## **SUMMARY OF DECISION – DESIGN REVIEW MINOR MODIFICATION**

**Project Name:** Village at Totem Lake – Phase II (Upper Mall)

**File No.:** DRV16-00914

Hillside Park - Plan revisions

OVERALL 120TH AVENUE NE / EVERGREEN FRONTAGE PLAN

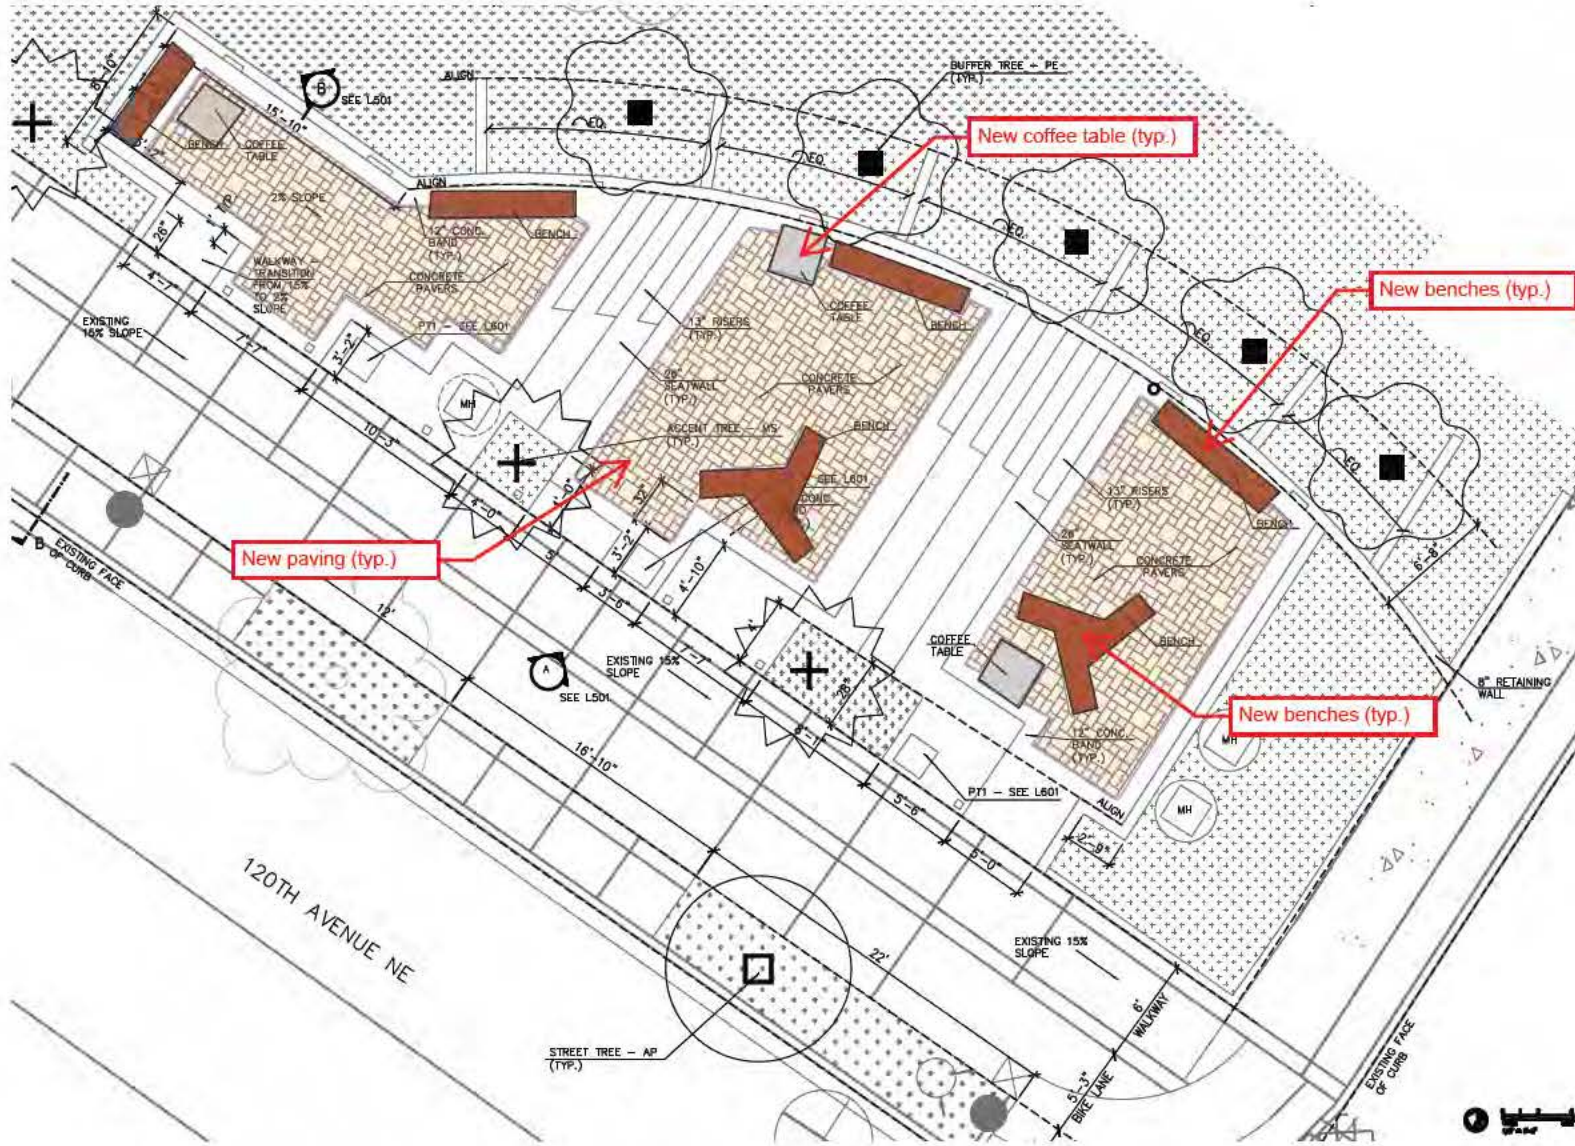
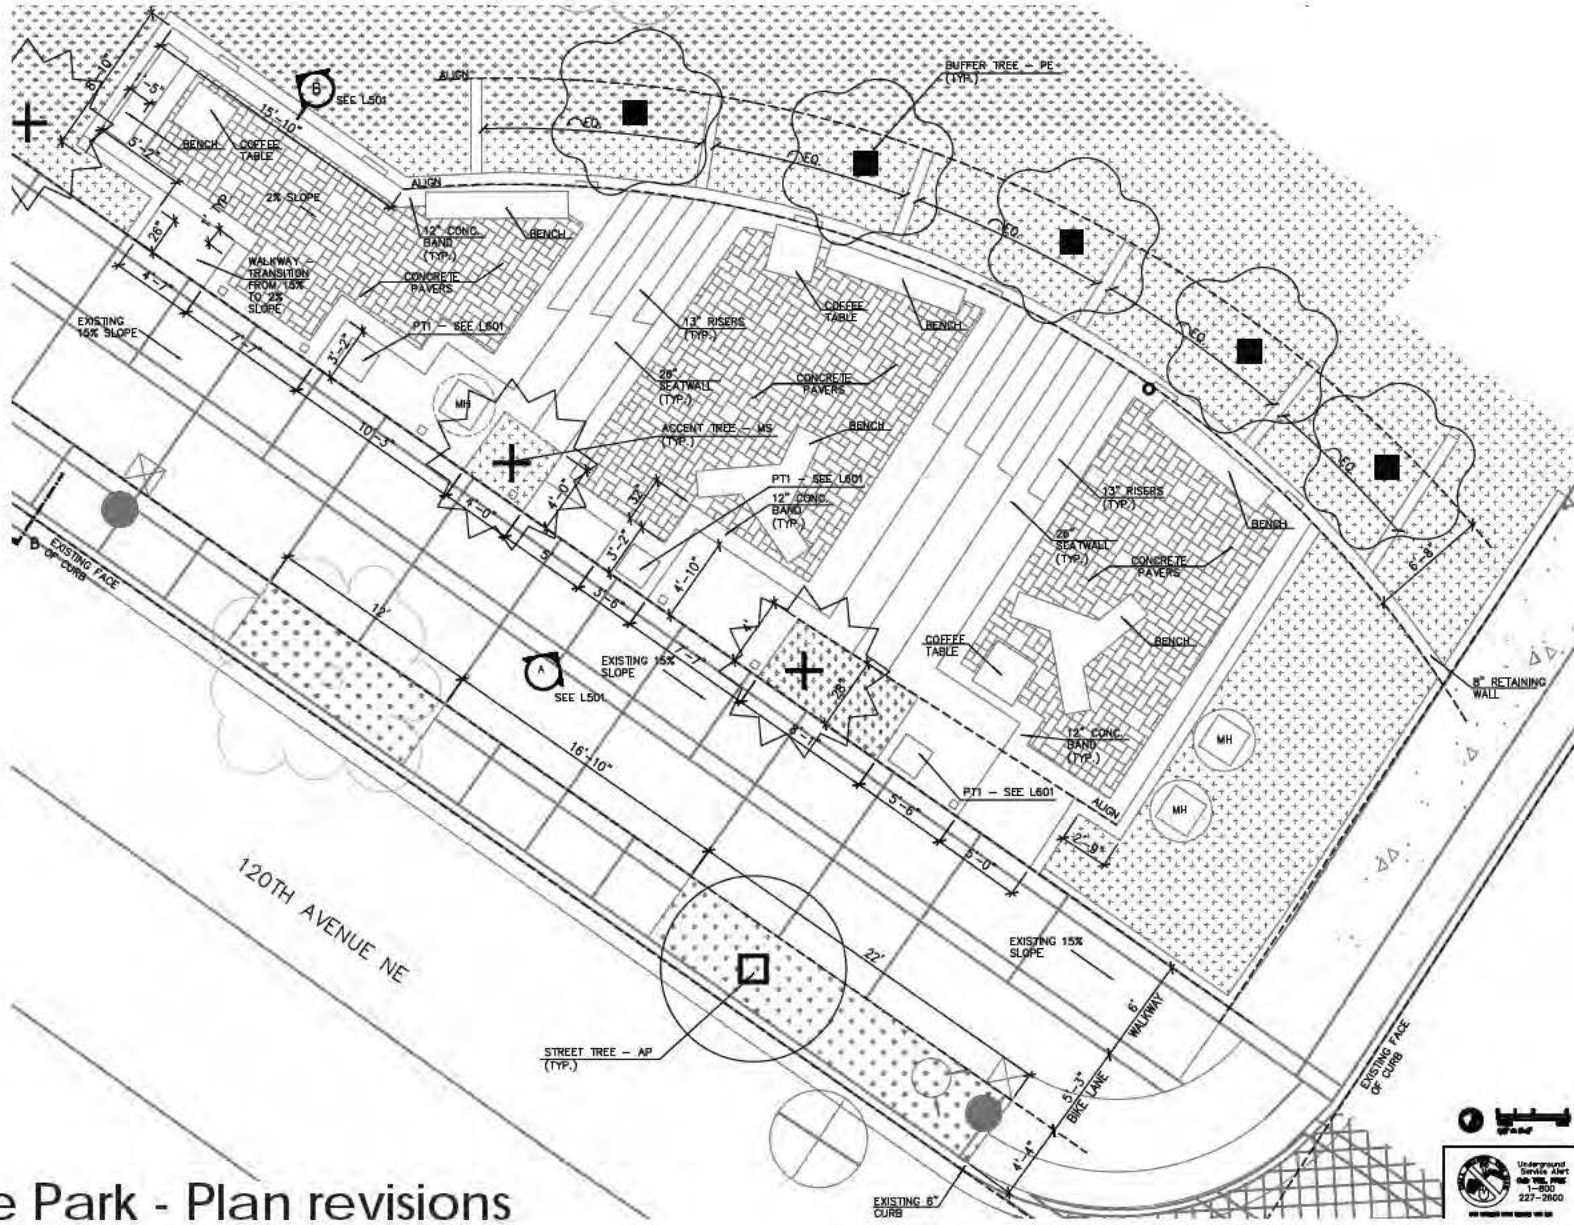
That section of 120th Ave NE north of the Village is quite steep; the hardscaped park, with multiple levels of seating and "entries" will provide both a visual and functional break for pedestrians. I notice there appear to be separate sidewalks (pedestrians) and bike lanes, although they seem to be co-planar and connected (even onto the Village property south of the loop road). Do we know if there will be separate paving materials or textures? The numerous curb cuts will be a challenge, on sloping and warped/curved surfaces.

I am a bit concerned with the interaction/conflict with pedestrians and bikers as they cross the loop road; the loop road at that point is also a major entrance/exit for a good chunk of the parking garage (the original design had the pedestrian crossing east of the garage entry/exit...and an even earlier proposal had a bridge from the apartment plaza level that flew above the loop road). The loop road exit markings indicate both north and south exiting will be allowed; southbound exiting will be VERY difficult as there is no middle turn-lane refuge at that portion of 120th Ave NE...and pedestrians/bikes will be fighting vehicles who've nosed out waiting for a gap as they attempt to look uphill at an angle. Although this minor element doesn't really impact the design of the new park itself, concentrating all of the foot and bike traffic at a fairly wide loop road gap is a result of abandoning the crossing further east.

There bike lane and sidewalk will be made of different materials to delineate where each mode should go. The entrance to the garage will also include marked crossings since it is a curb return instead of a driveway apron, so that should create a heads-up moment for people driving, walking or biking in the intersection. The proposed change does not really impact the design at the loop road, but please note that this location is set up with conduit and foundations for a future traffic signal, if and when it is warranted.
